REQUEST FOR INFORMATION	DATE: April 20, 2016	NO.: RFI-045
--------------------------------	-----------------------------	---------------------

Project Name: Webster University Interdisciplinary Science Building

Subject: Steel detailing questions

S0106

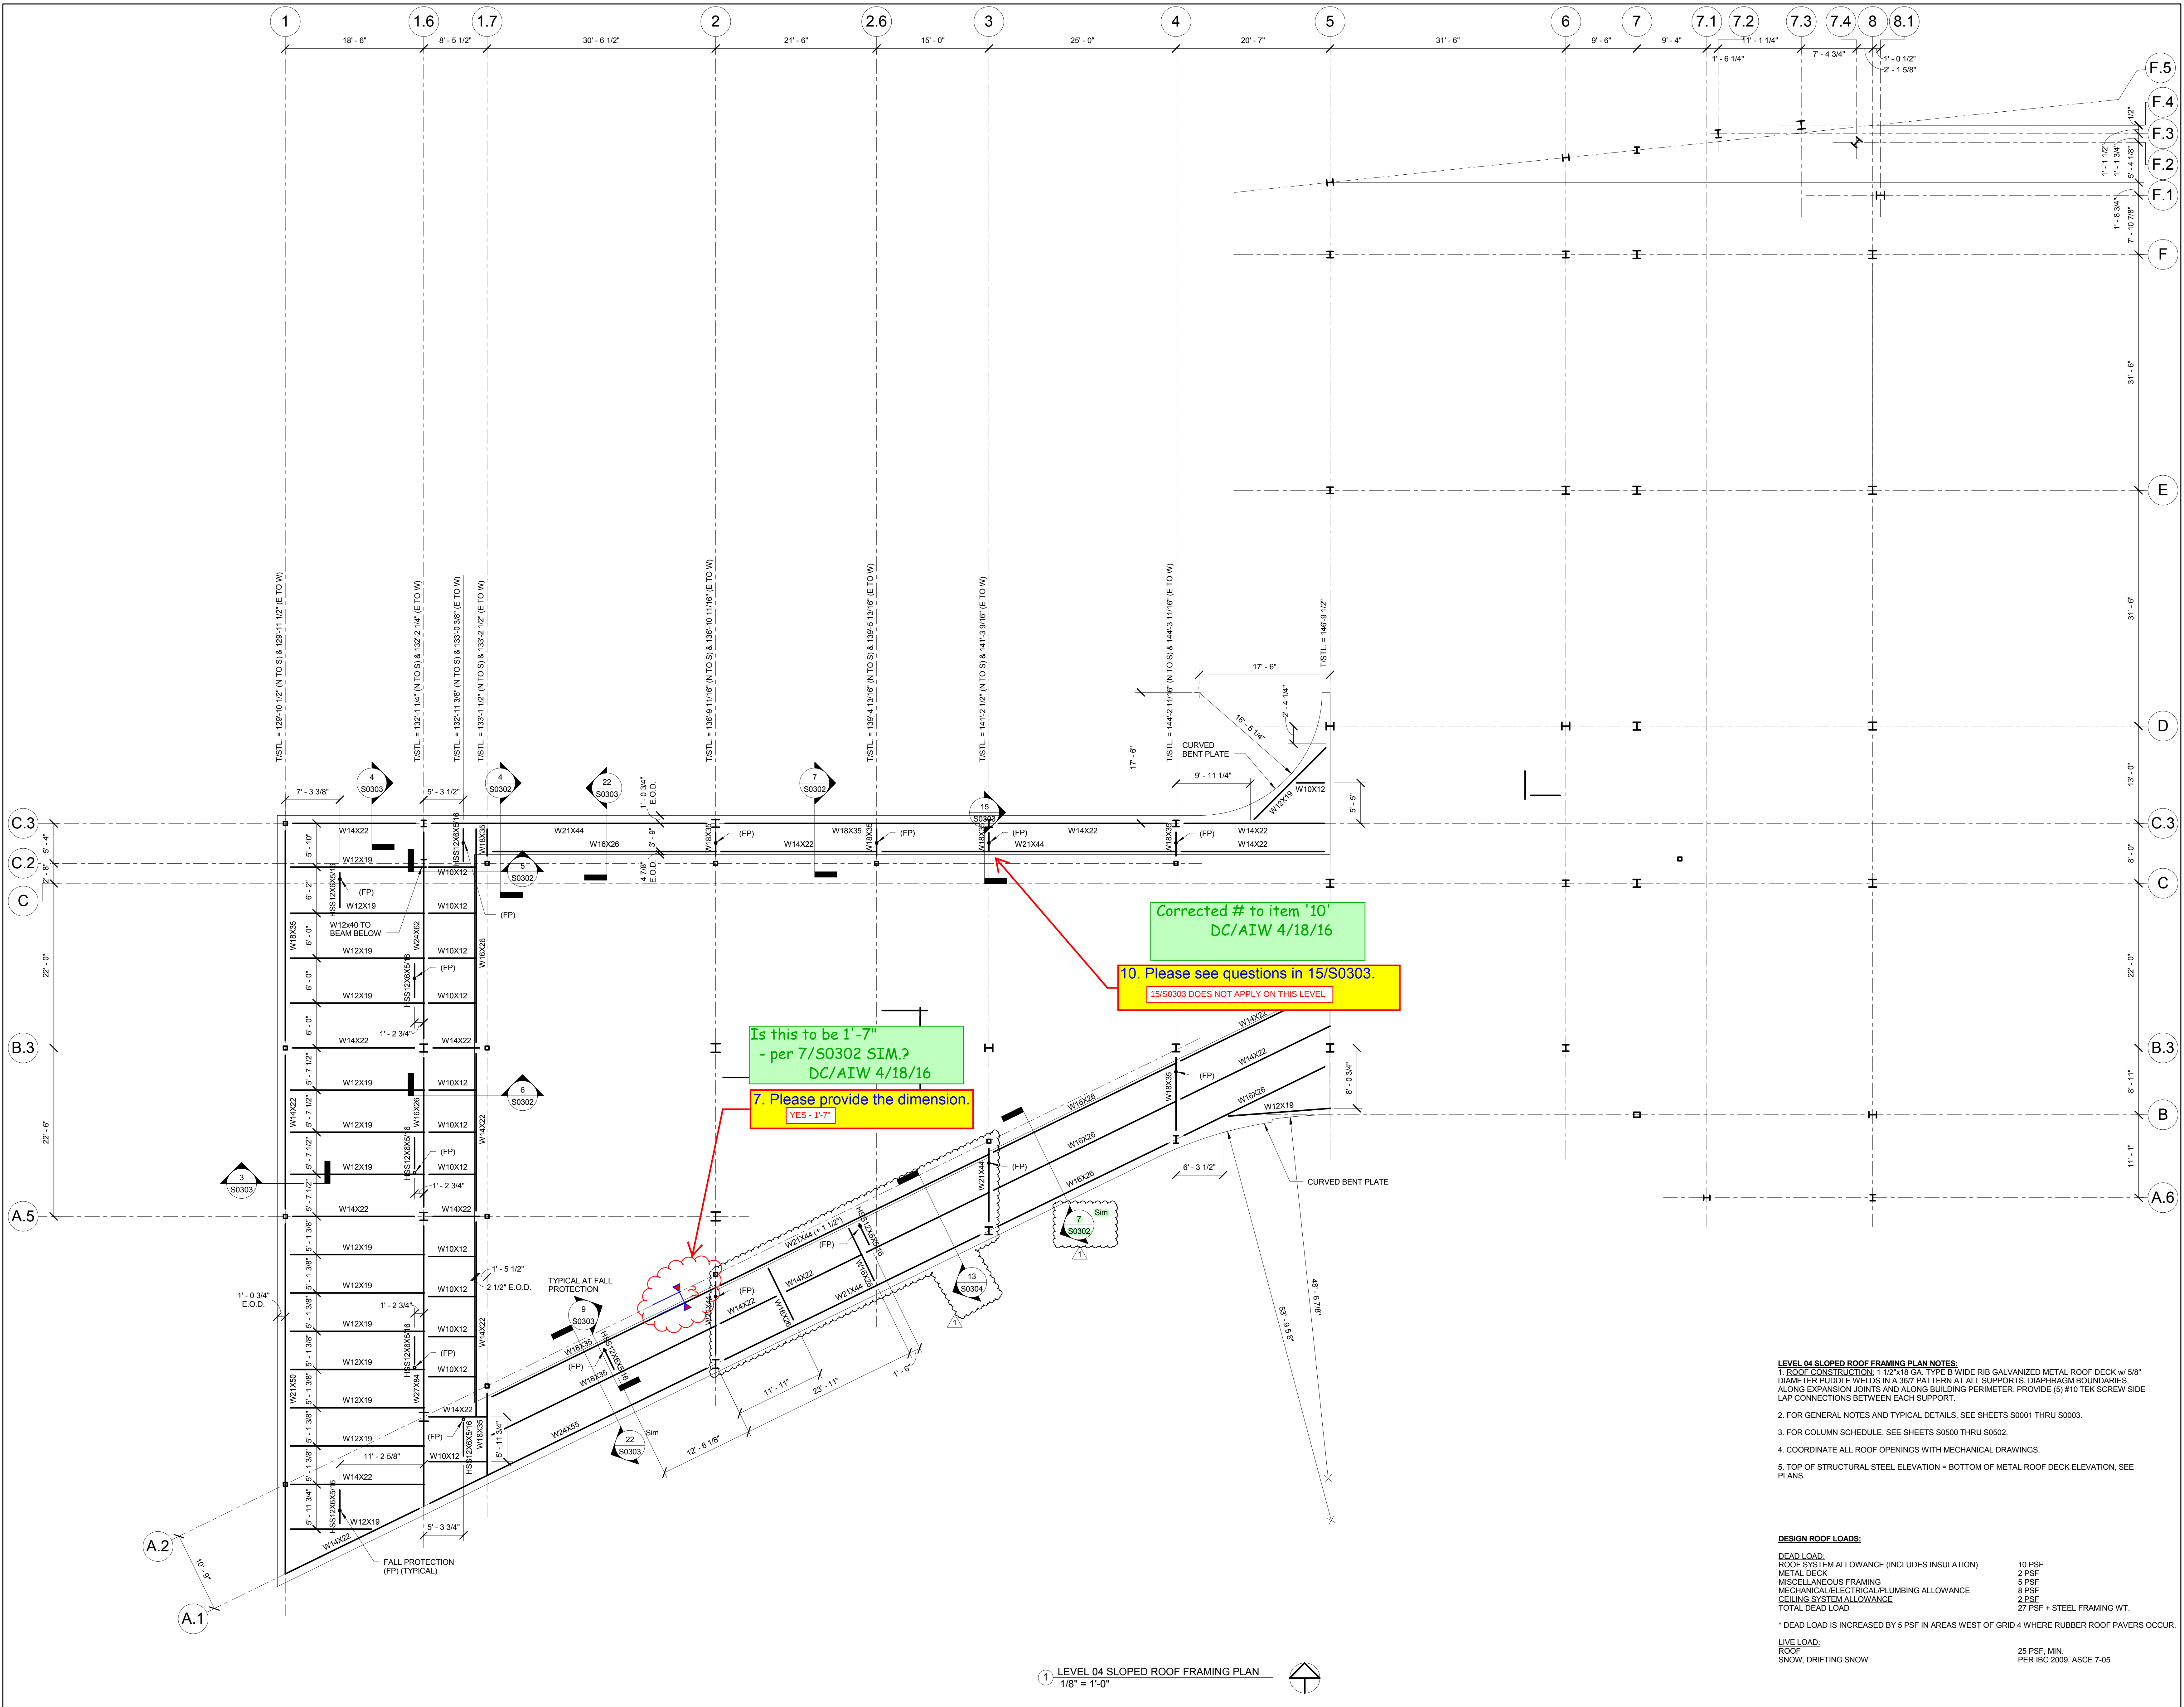
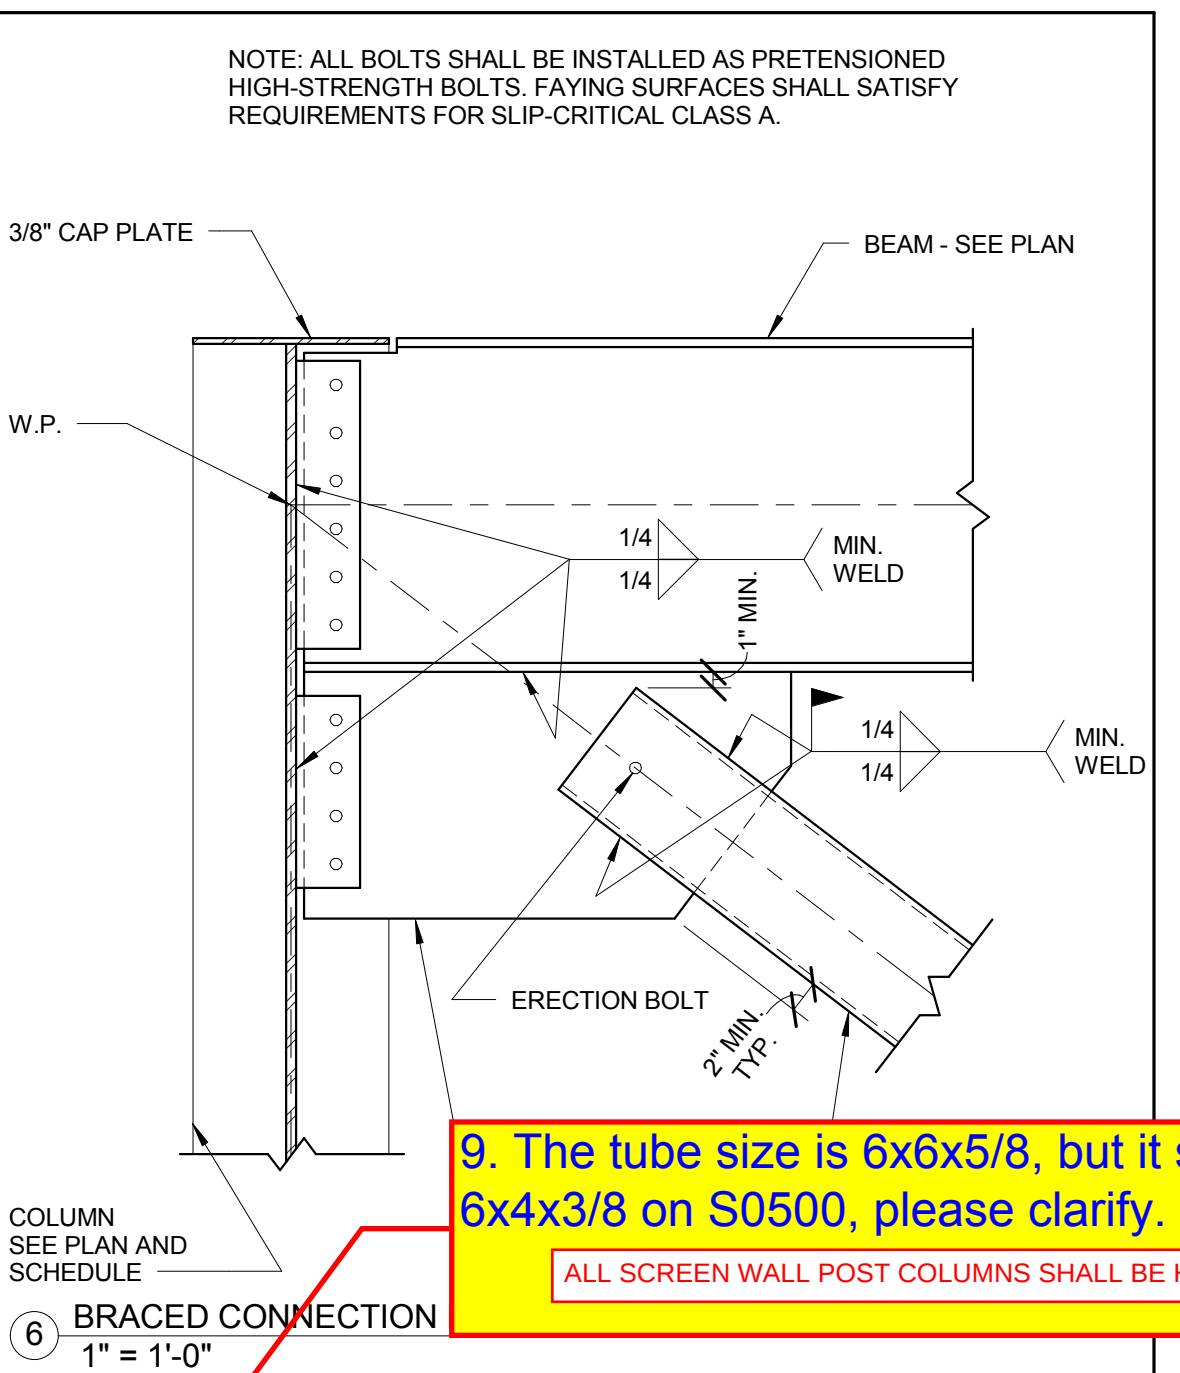
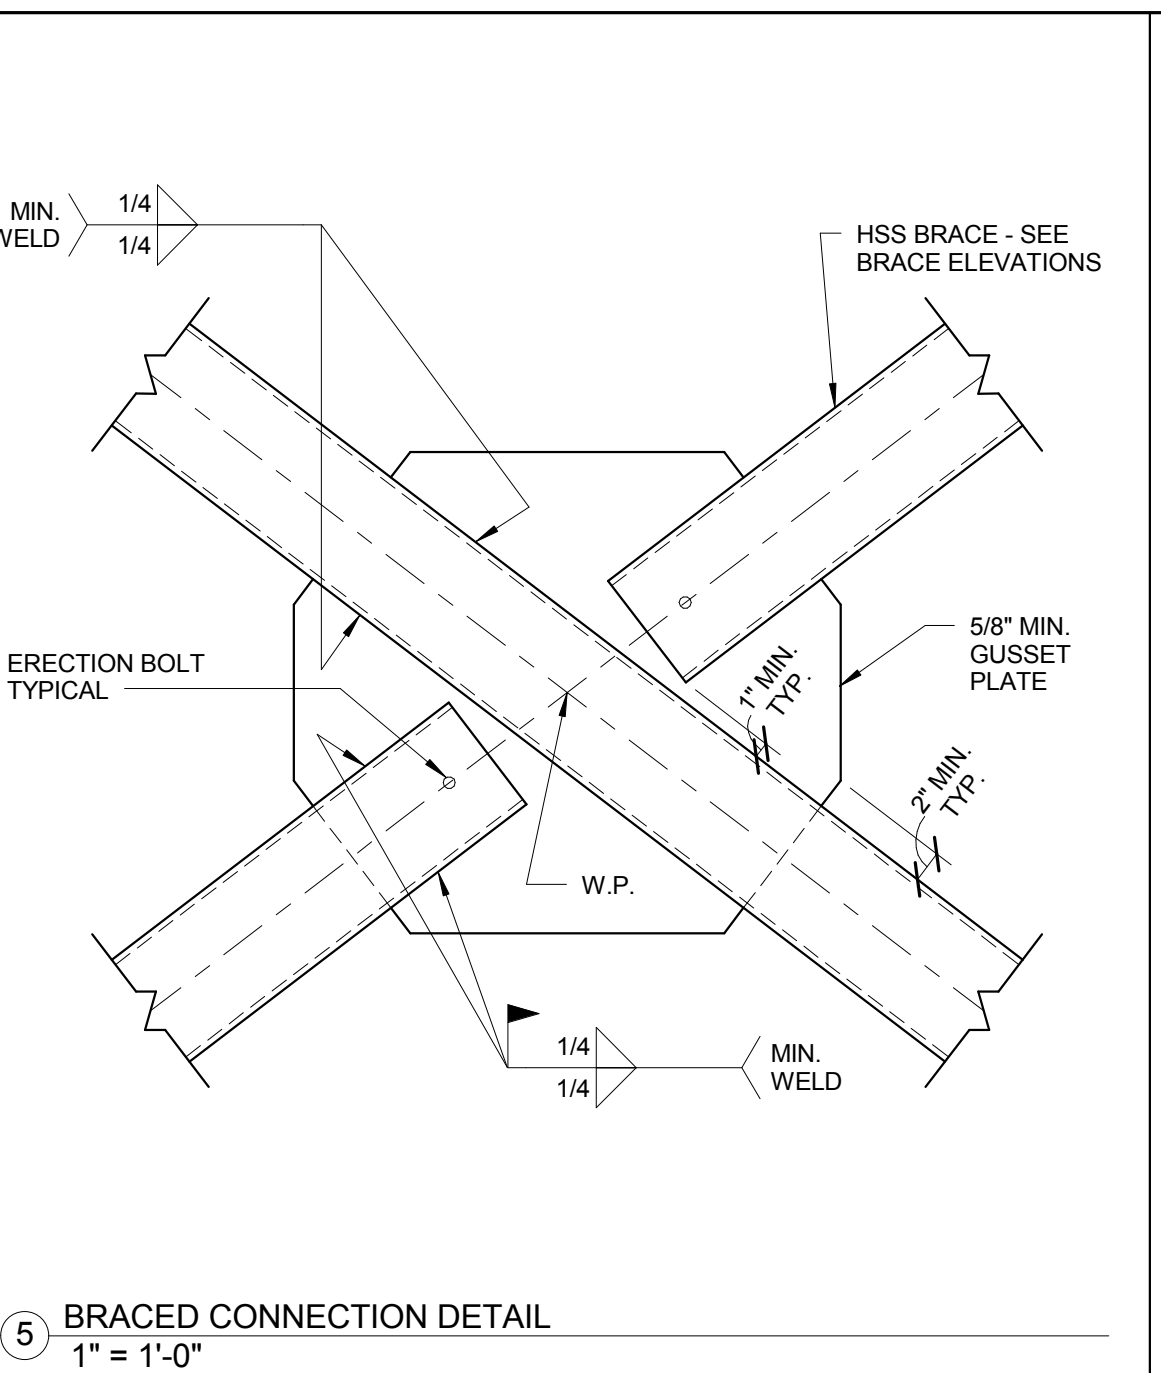
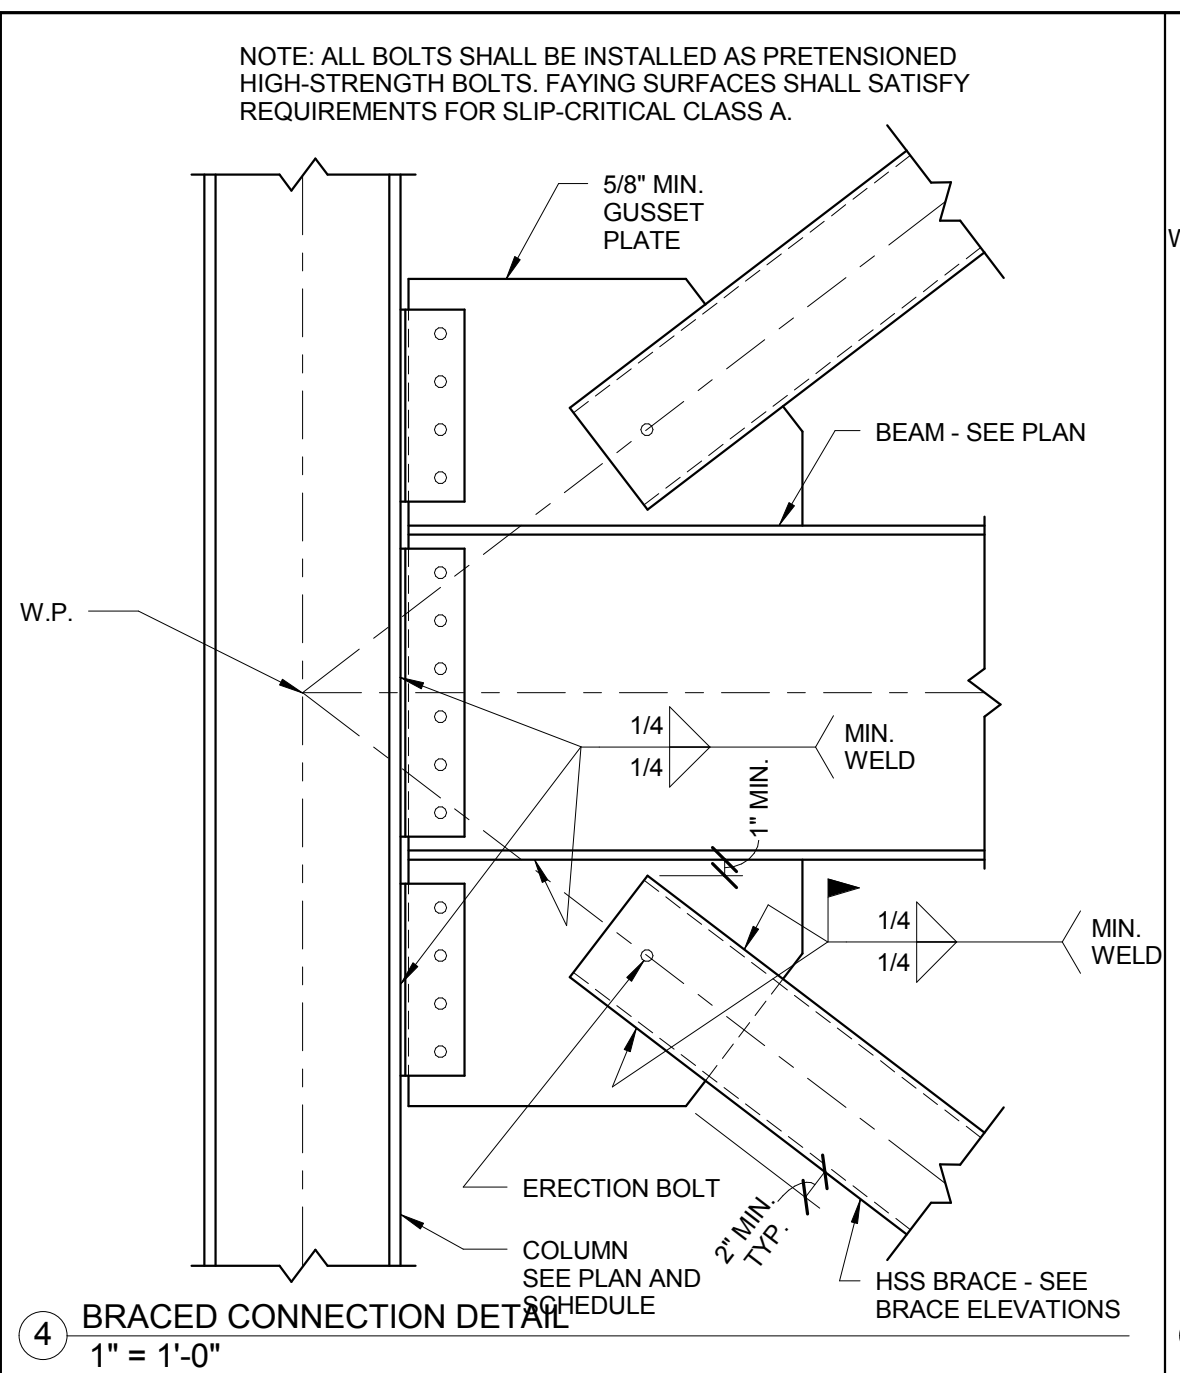
9. The tube size is 6x6x5/8, but it shown
6x4x3/8 on S0500, please clarify.

ALL SCREEN WALL POST COLUMNS SHALL BE HSS6X6X5/8"
